# COVER SHEET

Mark-up Legend	
Building Review	
Engineering Review	
Fire Review	
Planning Review	
Public Works Review	
Traffic Review	
APPROVED	
BY	CITY OF PUYALLUP DEVELOPMENT ENGINEERING
DATE	
NOTE: THIS APPROVAL IS VOID AFTER 180 DAYS FROM APPROVAL DATE. THE CITY WILL NOT BE RESPONSIBLE FOR ERRORS AND/OR OMISSIONS ON THESE PLANS. FIELD CONDITIONS MAY DICTATE CHANGES TO THESE PLANS AS DETERMINED BY THE DEVELOPMENT ENGINEERING MANAGER.

FOR  
**ARCO ampm PUYALLUP**  
SEC. 33, TWN. 20 N, RGE. 4 E, W.M.  
CITY OF PUYALLUP, PIERCE COUNTY

HORIZONTAL SCALE: 1"=20', VERTICAL SCALE: 1"=2'

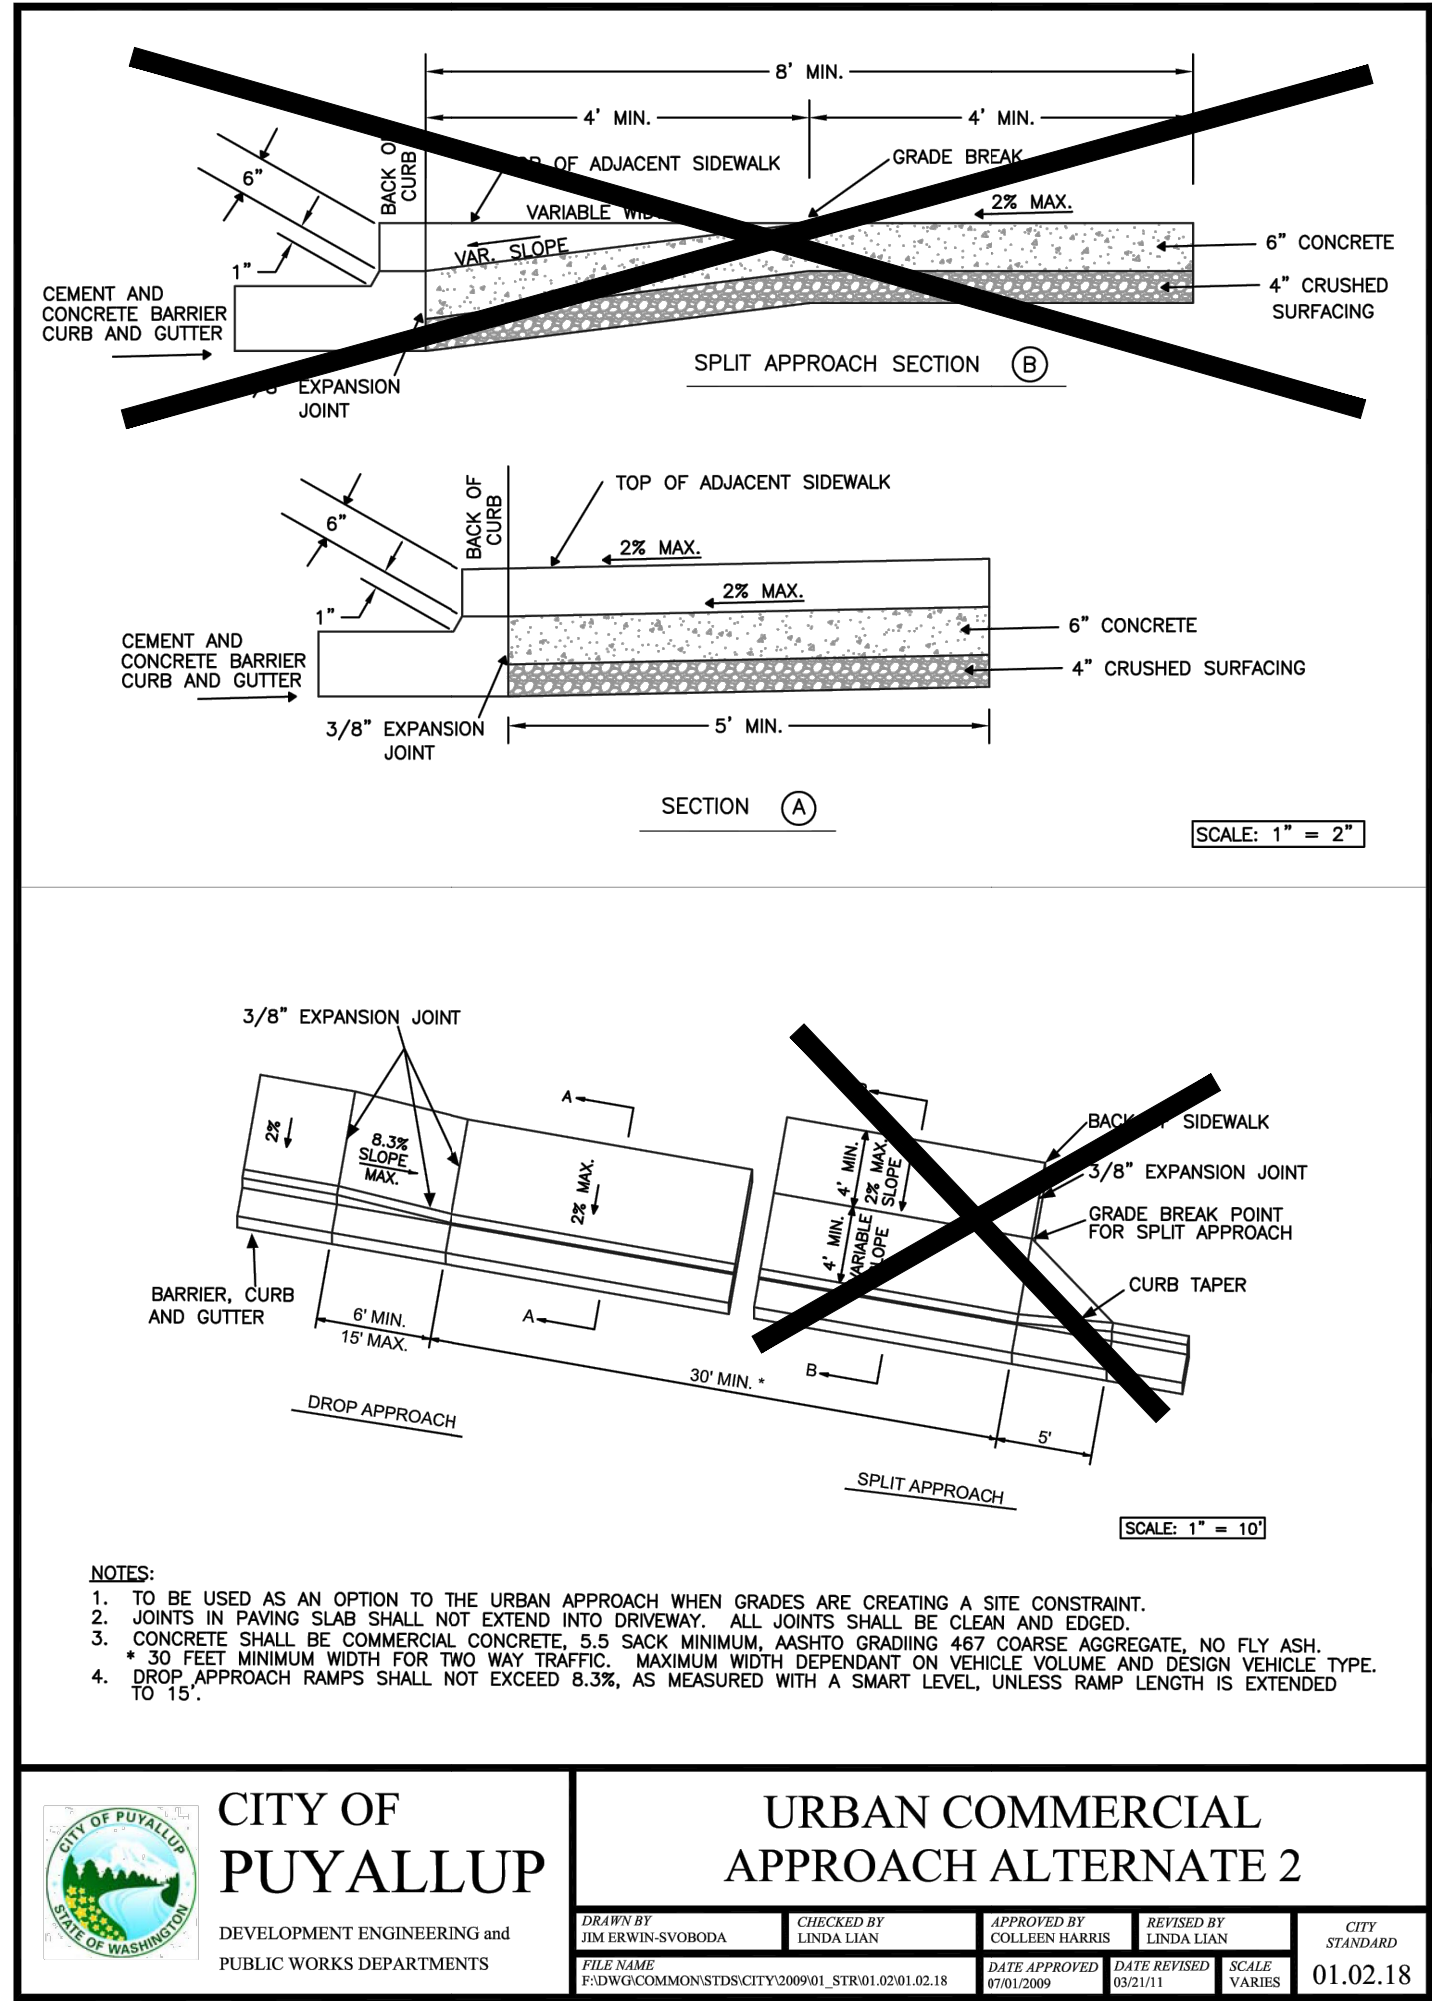
Create a note to have the contractor place a silt sock in the downstream CB to the west of this approach during construction. [civils, sheet C8.2]

Civil Resub Sheet C8.2: This existing fire hydrant has been hit more than once due to turn radius issues with this traffic access entrance/exit. Now traffic on this access road will likely increase 20-fold. Concrete bollards cannot be used to protect the hydrant because they are not crash worthy and would create liability issues for the City. The hydrant needs to be relocated out of the potential large vehicle off tracking turn radius while providing a minimum 3-foot flat clear zone around the hydrant. This fire hydrant is currently placed behind the sidewalk, and it is located too close to the private access driveway that will allow every vehicle coming from northbound S Meridian, as well as any traffic from 15th Ave to access this proposed Arco fuel station / food mart. Just because the fuel tanker trucks that make deliveries to this development will not use this private access driveway does not mean traffic will not increase. Food delivery vehicles for the food mart will likely use this entrance, as well as private vehicles pulling trailers with recreational vehicles that want to fuel up at this development. We have high static water pressure on 15th Ave SW. If the fire hydrant gets hit and breaks the foot of the hydrant below ground, it could potentially take out one of the existing buildings or the access driveway itself, leaving your development without access from northbound S Meridian. If the existing sidewalk is wide enough to allow the fire hydrant to be relocated 15-feet to the east and placed behind the 15th Ave curb per City Standard detail 03.05.01 it should be back far enough to be safe from traffic off-tracking. Having the fire hydrant relocated, would allow the driveway approach radius to be widened and fortified to support the additional vehicle traffic.

If existing asphalt is to remain and be used for forms must be protected and have no concrete residue or staining on road when complete...  
Sheet C8.2 SH

Civil Sheet C8.2: This existing fire hydrant has been hit more than once due to turn radius issues with this traffic access entrance/exit. Now traffic on this access road will likely increase 20-fold. Concrete bollards cannot be used to protect the hydrant because they are not crash worthy and would create liability issues for the City. The hydrant needs to be relocated out of the potential large vehicle off tracking turn radius while providing a minimum 3-foot flat clear zone around the hydrant.
